# **REGIONAL REVIEW NOTIFICATION**

#### ARC REVIEW CODE: R2012171

Name of Proposal: Kilburn-Gravel Springs Road (DRI #3213)Review Type: DRISubmitting Local Government: City of BufordDate Opened: Dec 17 2020Deadline for Comments: Jan. 1, 2021Date to Close: Jan. 4, 2021

**Description:** A Development of Regional Impact (DRI) review of a proposed project to build two warehouse/distribution buildings totaling 958,896 SF in the City of Buford. The 90-acre site is located off Gravel Springs Road (SR 324) north of I-85. Proposed access would be a new driveway on Gravel Springs Road and one on Brown Road. The local trigger is a proposed annexation from unincorporated Gwinnett County into the City of Buford. This project is seeking expedited review from GRTA for limited trip generation. Expected buildout is 2022.

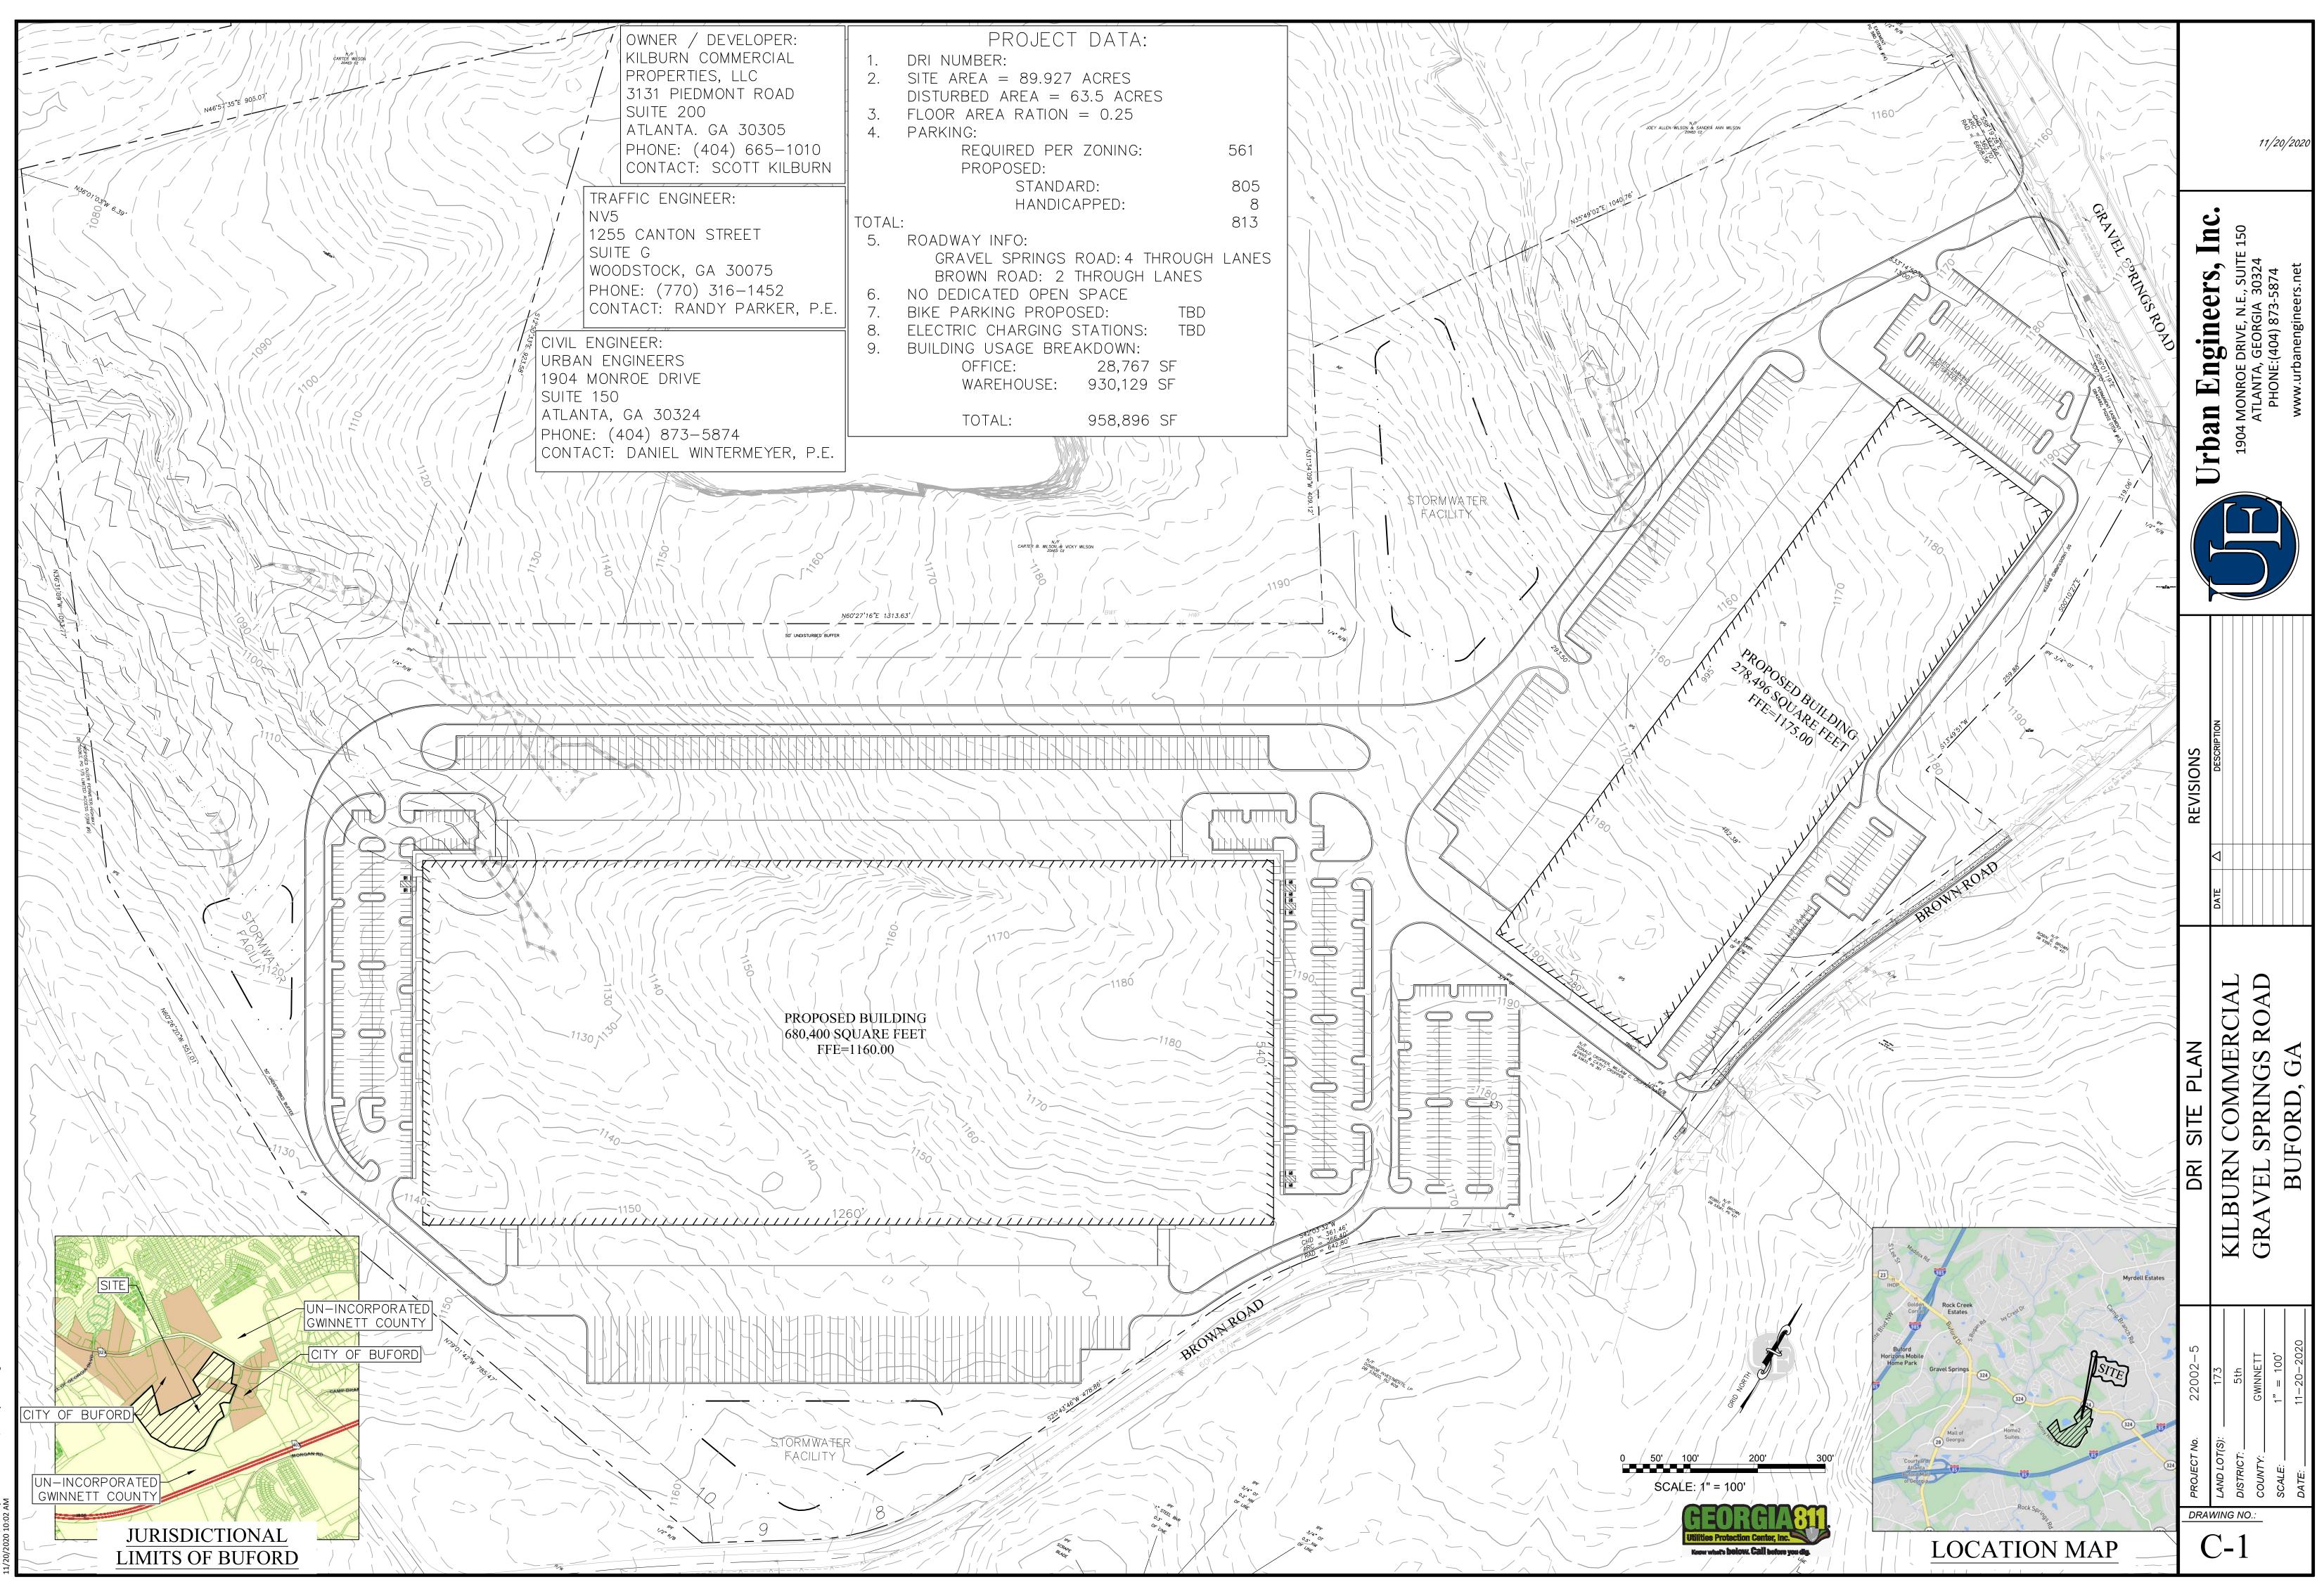
In addition, ARC encourages the applicant team to ensure that the development promotes a functional, safe, clearly marked and comfortable pedestrian experience on all proposed driveways, paths and parking areas on the site. During the Pre-Review meeting held on Dec. 7, 2020, ARC and GRTA staff advised that a sidewalk should be built on Brown Road from the project's eastern entrance to the next property line. This is contained in GRTA's conditions.

The DRI's site design should provide sufficient truck parking to prevent trucks from queuing or waiting on any adjacent or nearby roads. Trucks parking in and along public roadways – typically while waiting for an available dock at a nearby facility – is an identified issue in many areas of the region that negatively impacts roadway operations, safety and congestion. Signage and other measures to ensure drivers use the appropriate freight routes should be emphasized.

The USGS coverage for the project area does not show any blue line streams on or near the property. T project site plan shows three streams starting within the property and flowing towards the north and northwest. All three streams show 50-foot stream buffers and 75-foot impervious setbacks that appear to be consistent with the City of Buford's stream buffer ordinance, as well as the 25-foot State Sediment and Erosion Control buffer. The site plan shows a proposed driveway crossing the buffers at the headwaters of the easternmost stream and portions the entrance to truck bays, a parking lot and part of one building over a portion of one of the streams on the west side of the property. This construction may require a variance under the City's stream buffer ordinance and the State's Sediment and Erosion Control ordinance. Any unmapped streams on the property may be subject to the City's stream buffer ordinance, and all waters of the state on the property are subject to the State 25-foot Sediment and Erosion Control buffer.
